SCHEMATIC REVIEW - APPROVED

RE: QUIZNOS SUB
BP-Hwy. 305 and Church Road - Store # 11816
BP-Hwy. 305 and Church Road
Olive Branch, MS 38654
(Accepted 3-20-07)

* Quiznos does not have a separation of space therefore common seating will be required. Seating will not be provided by Quiznos. 1,045 S.F. #11816 SCHEMATIC

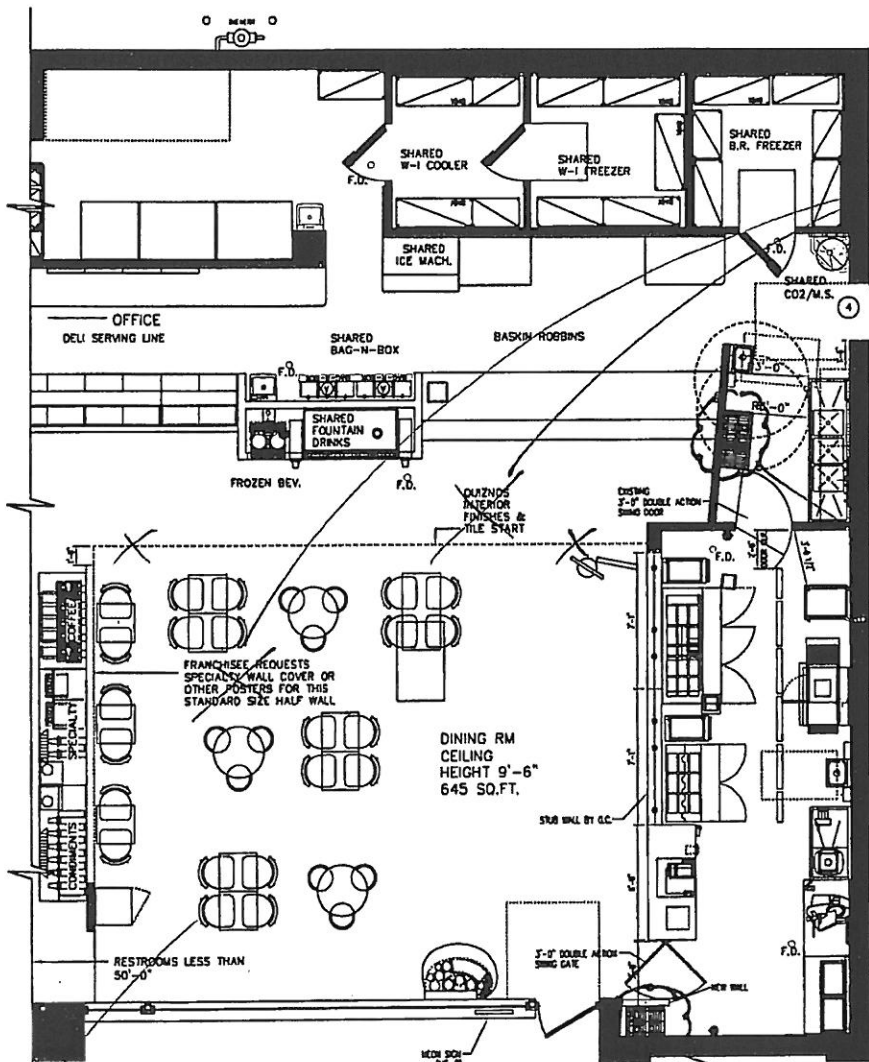
- ★ a. Quiznos does not have a complete separation of space therefore the dining room floor finishes, wall finishes and seating must all be provided by the C-Store. (see attached)
- ★ b. Verify if the custom 3-comp sink is to be provided by Quiznos or by the C-Store. (see attached)
- ★ c. Verify if the shelving units shown are to be provided by Quiznos or by the C-Store. Please note that a minimum of (4) 18x36 shelving units are required and must be shown. Verify location of additional dry storage shelving. (see attached)
- ★ d. Show the soup poster (G4) behind the soup station per the prototype. (see attached)

* Quiznos does not have separation of space therefore common finishes are required.
 * Verify if Quiznos or CtG will be providing custom 3-comp sink.

NON-STANDARD 3-COMP SINK (26" X 90" MODEL 314-16-3-18)

* By Quiznos? Verify.

TOASTER MUST BE LOCATED 6" TO 8" AWAY FROM FRP

* Slow Soup poster.

* Shelving By Quiznos? Verify.
 * Verify if additional dry storage will be provided for Quiznos.
 * Please note a minimum of (4) 18x36 shelving units are required and must be shown. Location?
